# Access Compliance Report

## Public Rights-of-Way

### (Curb Ramps)

Intersection ID: 27628	Main Street: BALLANTYNE COMMONS PY	Cross Street: ADAIR MANOR CT	Location: SE
ADA ID: 3DF6CBEE9543	Ramp Type: Perp	Initial Pass/Fail: Fail	Overall Compliance: No
Severity Score: 22.5			
Codes/Mitigation Info/Possible Solution		Field Measurements/Component Compliance

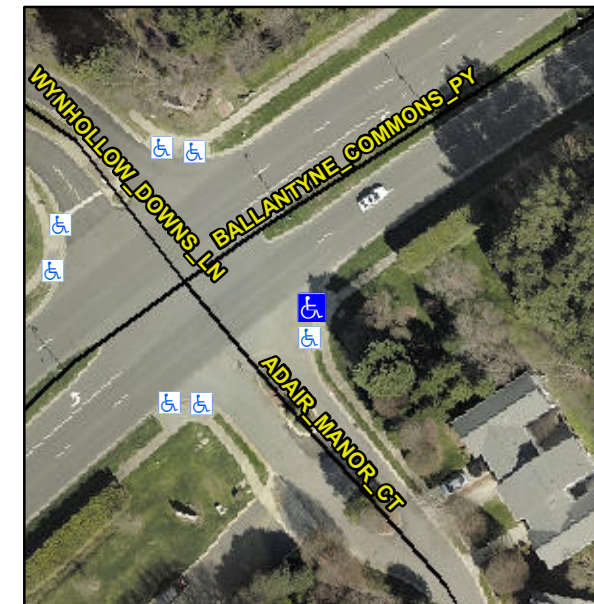
**Not Found, R304.5.1, R304.2.2, R304.5.3**

Compliance	Description	Data	Compliance	Description	Data
N/A	Ramp Length (in)	118.0	No	Ramp Slope (%)	8.8
No	Ramp Width (in)	41.0	No	Ramp XSlope (%)	4.5
N/A	Flare Type LT	N/A	N/A	Flare Type RT	N/A
N/A	Flare Slope LT (%)	N/A	N/A	Flare Slope RT (%)	N/A
N/A	Flare Traversable LT?	N/A	N/A	Flare Traversable RT?	N/A
N/A	Landing Length (in)	N/A	N/A	DWS Provided?	N/A
N/A	Landing Width (in)	N/A	N/A	DWS Contrast?	N/A
N/A	Landing Slope (%)	N/A	N/A	DWS Length (in)	N/A
N/A	Landing X Slope (%)	N/A	N/A	DWS Full Width?	N/A
N/A	Landing Curb? (Y/N)	N/A	N/A	DWS Offset (in)	N/A
N/A	Shared Landing?	N/A			
N/A	Gutter Ponding?	N/A	N/A	Gutter Slope (%)	N/A
N/A	Gutter Lip Ht (in)	N/A	N/A	Gutter X Slope (%)	N/A
N/A	Painted X Walk1?	No	N/A	Painted X Walk2?	N/A
	X Walk 1 Direction	To NW		X Walk 2 Direction	N/A
N/A	X Walk 1 Width (in)	N/A	N/A	X Walk 2 Width (in)	N/A
	X Walk 1 Slope (%)	4.0		X Walk 2 Slope (%)	N/A
	X Walk 1 X Slope (%)	2.4		X Walk 2 X Slope (%)	N/A

**Remove & Replace Entire Ramp.**
